Infiltration Testing

Construction of SA1

Figure 1 Infiltration rates as recorded by Southern Testing

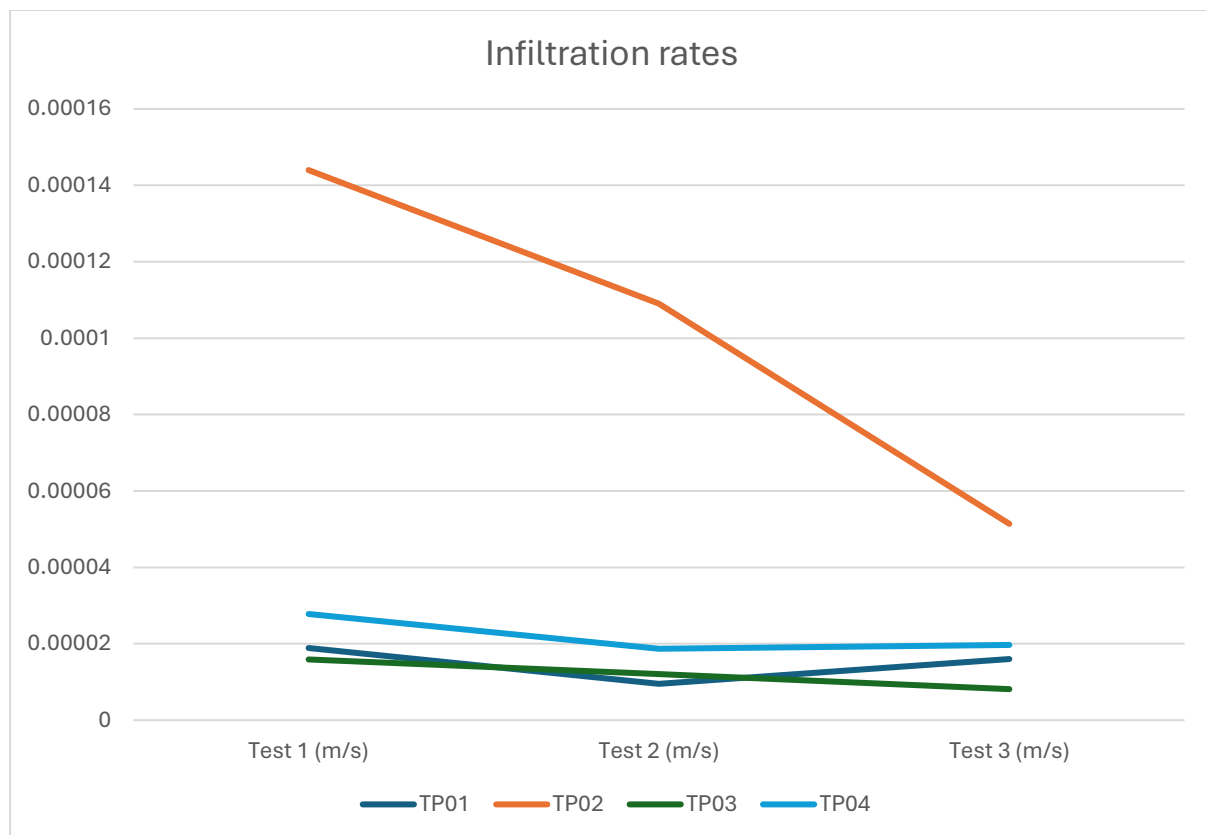
Only the testing on TP02 was compliant with BRE 365. However, TP02 cannot validate the design infiltration rate, as the rate adopted in the drainage design was derived from TP03. There is something extremely interesting that stems from the analysis of these two tables, and is best illustrated in the following graph:

As evidenced above, the testing at TP02 was the only testing which complied with both BRE 365² and ADC's own requirements³ in that all three tests were carried out in quick succession, and in fact were on the same day. The graph therefore provides a singular, site-specific indication of the effect of successive saturation: at TP02, the measured infiltration rate deteriorated by 52.8% between tests two and three.

For the tests that were not conducted in accordance with the published requirements, the intervening periods allowed the ground an opportunity to recover before the third test was undertaken. As is evident from the graph and tables, two of those subsequently produced a better infiltration rate in test three than in test two. Whilst it cannot be established retrospectively that recovery was the cause of that improvement, the required successive-fill sequence was not completed and the resulting third-test values therefore cannot demonstrate how those trial pits would have behaved under continued successive saturation.

A correctly completed three-fill test demonstrating a reduction of more than 50% between the second and third successive fills provides direct, site-specific evidence that the infiltration

characteristics of the material can deteriorate materially under the successive saturation regime that BRE 365 is intended to test. Where the other trial pits were excavated within comparable ground conditions, it is therefore reasonable to consider that successive filling may also have materially affected their measured infiltration rates. It is not, however, possible to determine either the direction or magnitude of that effect retrospectively, because the prescribed third successive fills were not carried out.

Figure 2 Extract from submitted drawings

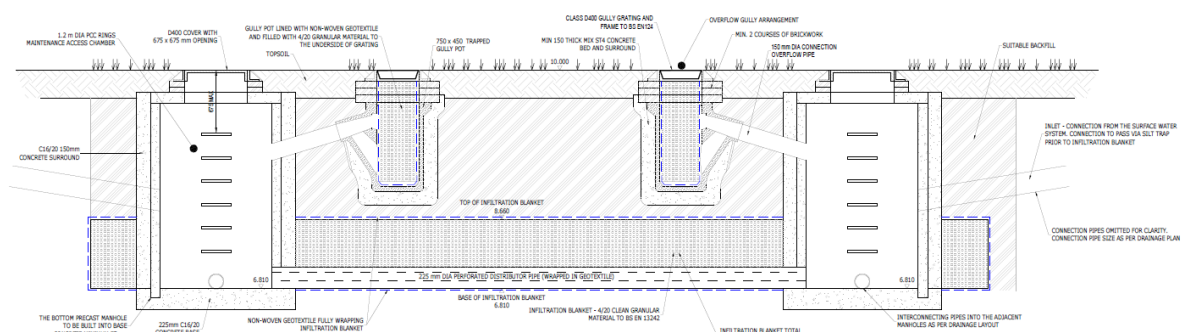
This shows, clearly, a ground level of 10.000m AOD, an invert of 6.810m AOD and the top of the infiltration blanket at 8.660m AOD. This shows that the infiltration blanket should be encountered at 1.340 metres below the surface, and the membrane at the invert should be 3.190 metres below ground.

These logs all appear to indicate that SA1 was never constructed to the depth shown on the submitted drawing. It is also concerning that TP02 records membrane only at the invert, whilst TP03 records no membrane at all.

This means that, even had the earlier applications been approved, the soakaway as constructed would not have delivered the drainage system presented in the submitted drawings, with the resulting effect upon its long-term performance remaining unknown and the associated risk ultimately borne by the residents.

Out of interest, and referencing the proposed levels under application 7, it would appear that the invert of SA1 should now be 2.930 metres below ground, so the existing SA1 is still not deep enough, even if we discount the presence of foreign materials contrary to the specification.
